ATTACHMENT 1 – Council Submission

SSD-90134958 - 100 Edinburgh Road, Castlecrag

Figure 1: Proximity to C4 Environmental Living Zone (outlined)

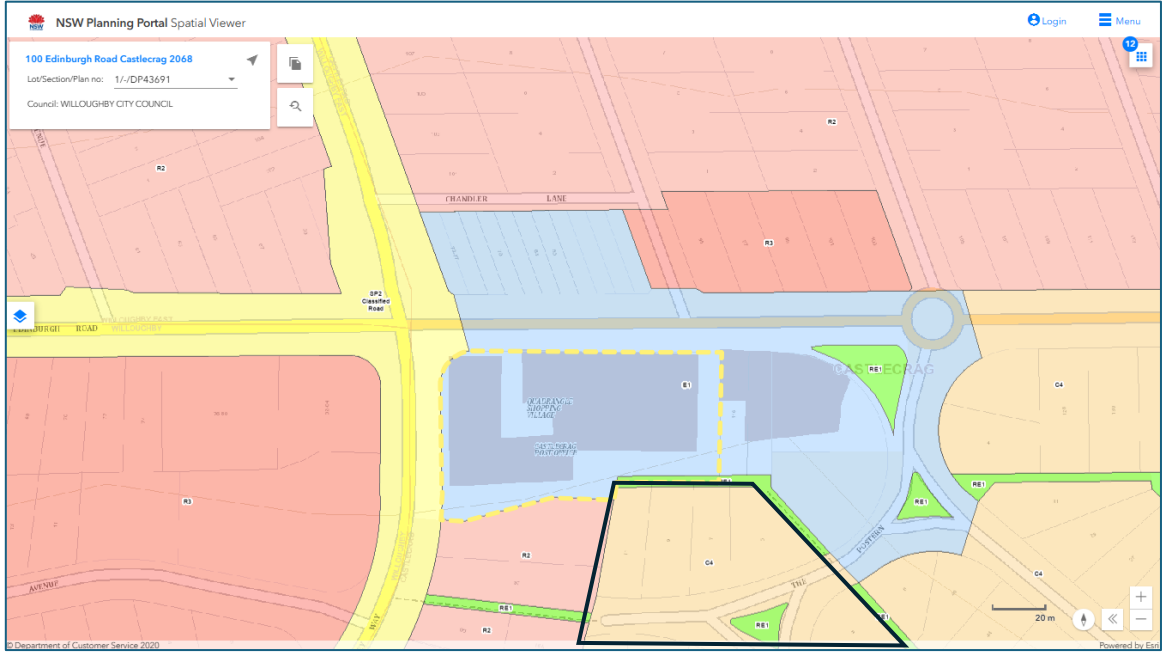
While the Low and Mid-Rise Policy is specified, the Griffin Heritage Conservation Area and C4 Environmental Living zone is not. This is indicative of the overall approach, which has privileged the adjoining Low and Mid-Rise area over the adjoining conservation area and Environmental Living zone.

Figures 1 through to 3 below shows the site's close proximity to the Griffin Heritage Conservation Area and the C4 Environmental Living zone.

Figure 3: Proximity to LMR Housing Area

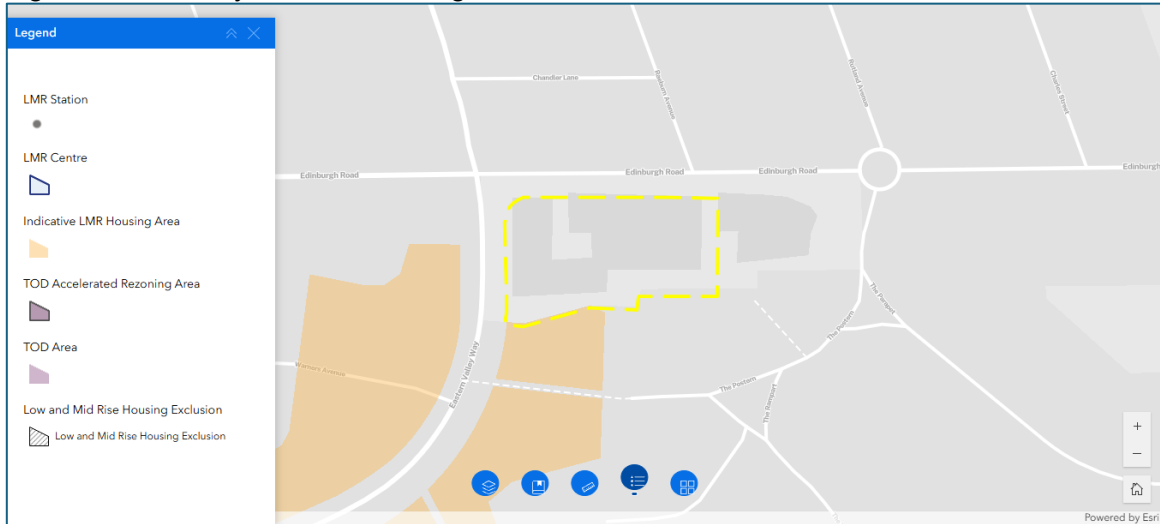
The Explanation of Intended Effects (EIE) overstates the relevance of the Low and Mid-Rise area to the sites south-west, and understates the relevance of the adjoining Griffin Heritage Conservation Area and C4 Environmental living zone. The development is substantially larger in scale and density that what would be permitted under the Low and Mid-Rise policy and will neither integrate nor complement the scale of development in the adjacent Low and Mid-Rise Area. Further, there is little to no regard to the scale of
